SUBJECT: Forwards responses to Reactor Sys Branch questions re steam line break analysis, per NRC 810109 telcon request. Info will be incorporated into FSAR & directly distributed as part of Amend 25.

Subject: Docket Nos. 50-361 and 50-362
San Onofre Nuclear Generating Station
Units 2 and 3

STEAM LINE BREAK ANALYSIS

CONFIRMATORY EVALUATION

FIGURE 1-1 COMPARISON OF STEAM LINE BREAK REACTIVITIES OBTAINED WITH DIFFERENT TIMES FOR INITIATION OF REACTOR COOLANT PUMP COASTDOWN

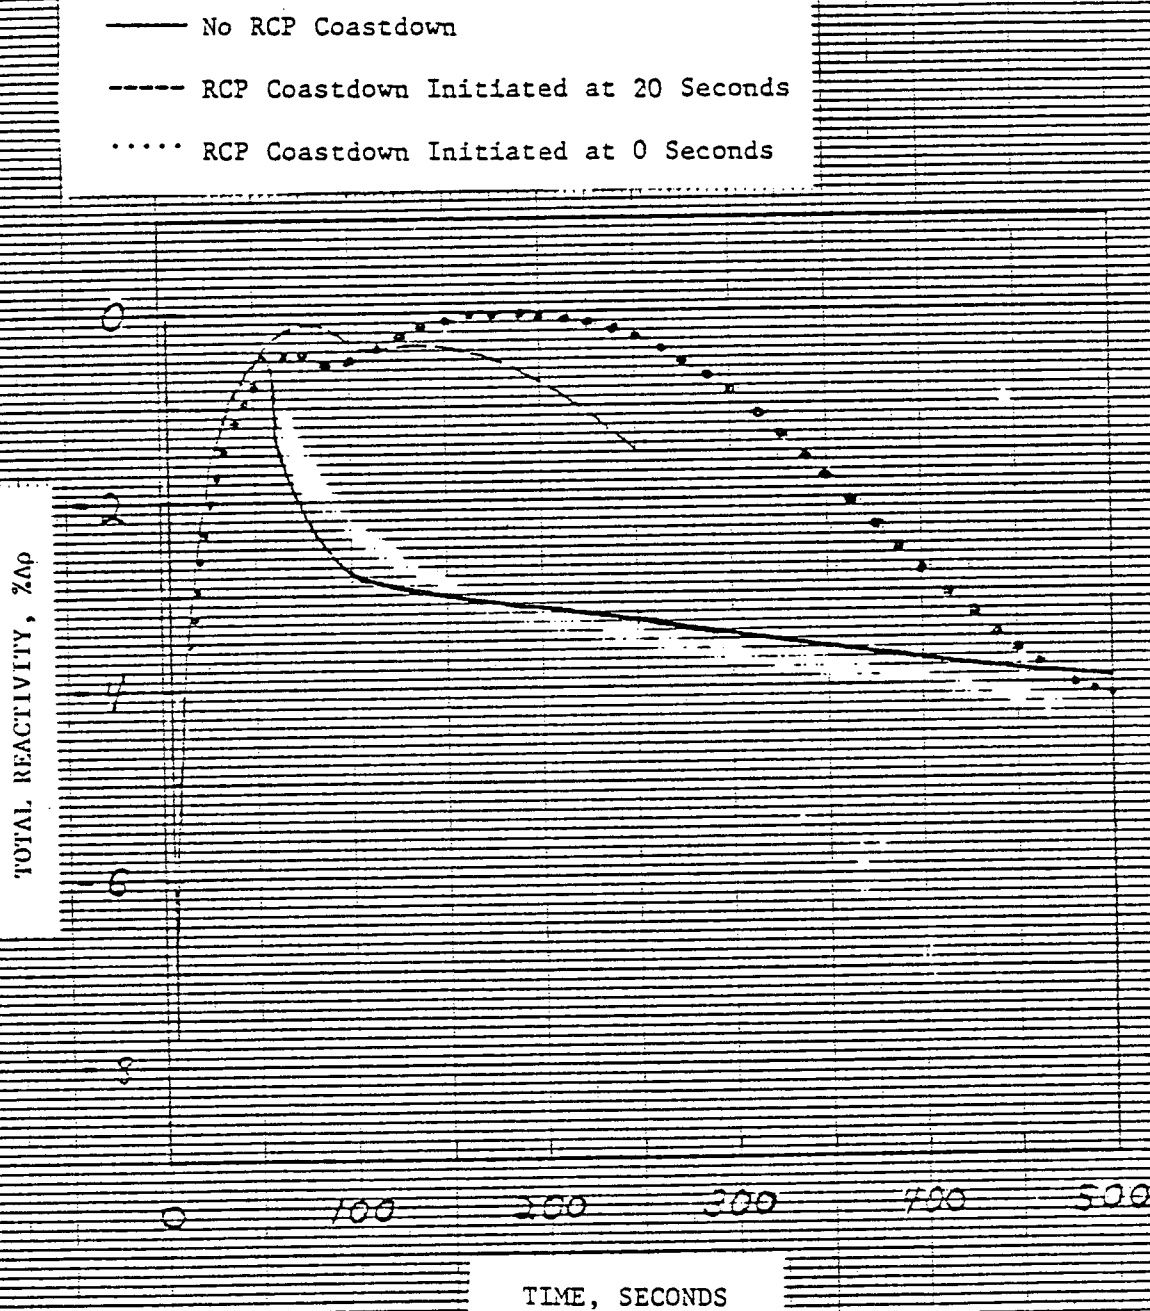
Question 1: Do the steam line break (SLB) analyses presented in the FSAR bound the transient which would result if the operator (following I&E Bulletin 79-06C guidance) tripped the reactor coolant pumps (RCPs) following safety injection actuation signal (SIAS) due to low pressurizer pressure?

Response: Evaluation of the effects of shutting off RCPs at various times during the SLB transient indicates that RCP shutoff following SIAS due to low pressurizer pressure does not alter the conclusions presented in the FSAR.

The effect of RCP shutoff following SIAS is illustrated for a large SLB initiated at full load conditions by the reactivity and heat flux transients presented in Figures 1-1 and 1-2, respectively. In each figure, the transients presented in the FSAR-- no RCP coastdown (solid line) and RCP coastdown at time zero (dotted line)-- are provided together with the transient (dashed line) resulting from RCP coastdown initiated at the time which causes the maximum post-trip return to power: 20 seconds after initiation of the transient (SIAS occurs at 13 seconds). Figure 1-1 shows that the transient total reactivity is bounded by the case presented in the FSAR: RCP coastdown initiated at time zero. The timing of the reactivity peak causes the maximum post-trip heat flux (Figure 1-2) to be slightly higher for the transient resulting from RCP coastdown initiated at 20 seconds than for either of the cases presented in the FSAR. This difference in post-trip heat flux is not sufficient to alter the conclusions presented in the FSAR.
